TENNESSEE VALLEY AUTHORITY

In my letter to you dated March 3, 1982, TVA provided information concerning submergence of electrical equipment at Watts Bar Nuclear Plant. This information was included as Appendix B of the referenced letter.

Enclosed are minor revisions to Appendix B for your information. These revisions from the previous submittal, which are circled for ready reference, do not affect the conclusions of the TVA analysis.

WATTS BAR NUCLEAR PLANT
LIST OF SUBMERGED ELECTRICAL EQUIPMENT
POWERED FROM CLASS 1E I&C POWER SYSTEM
GROUPED BY COMPONENT TYPE

FIGURE B-1.3.5

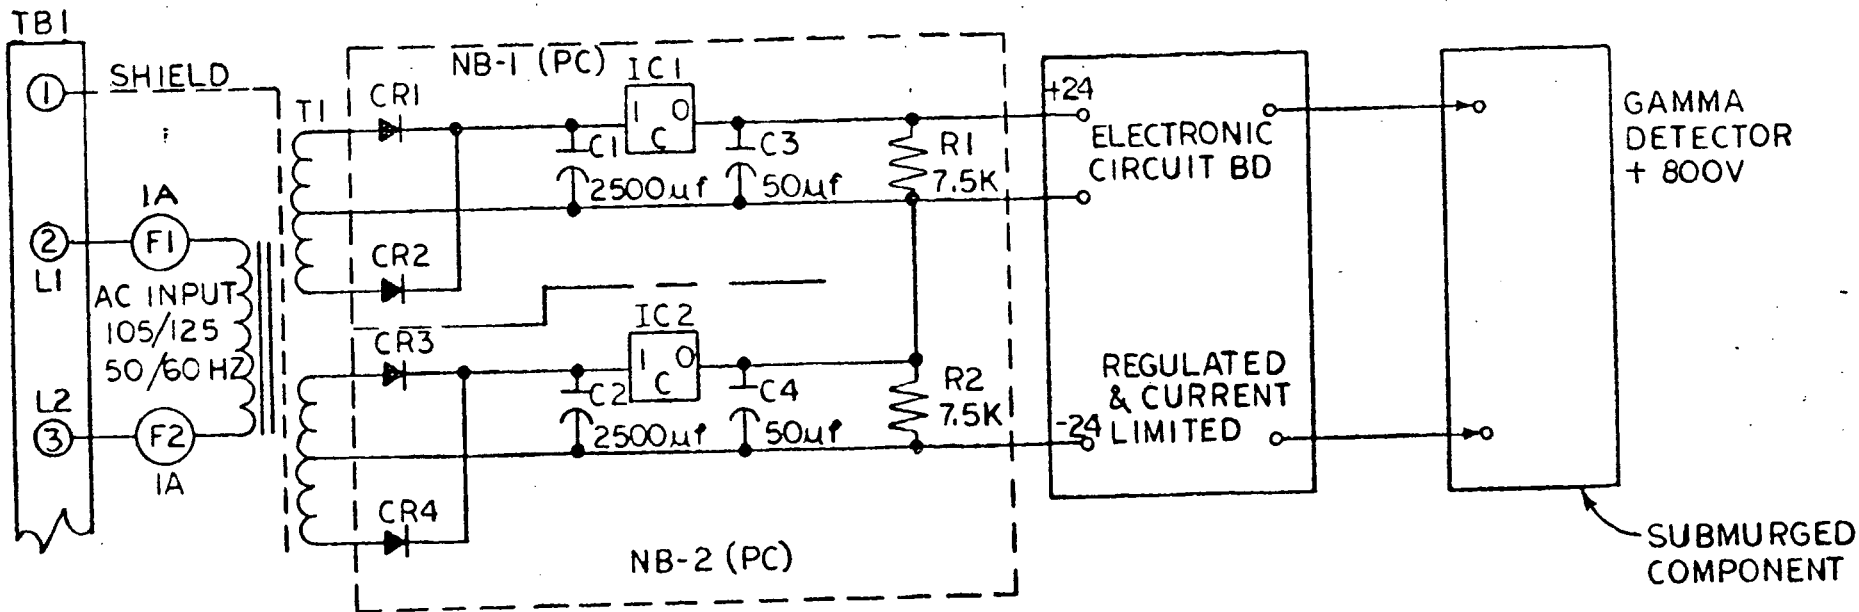
→ New Figure

FIGURE C-2-1.1A

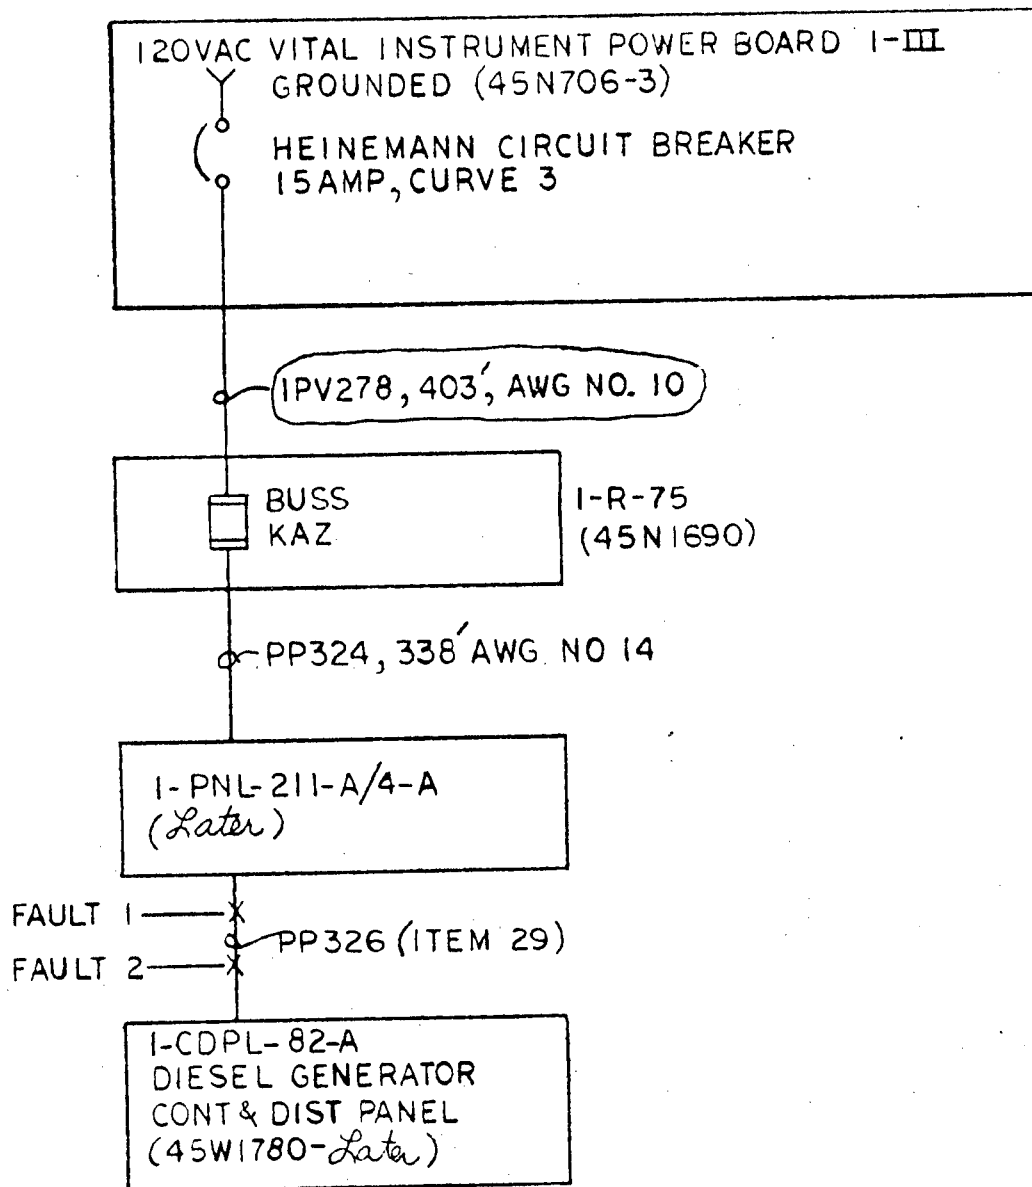
NEW MODIFICATION—DRAWINGS NOT ISSUED
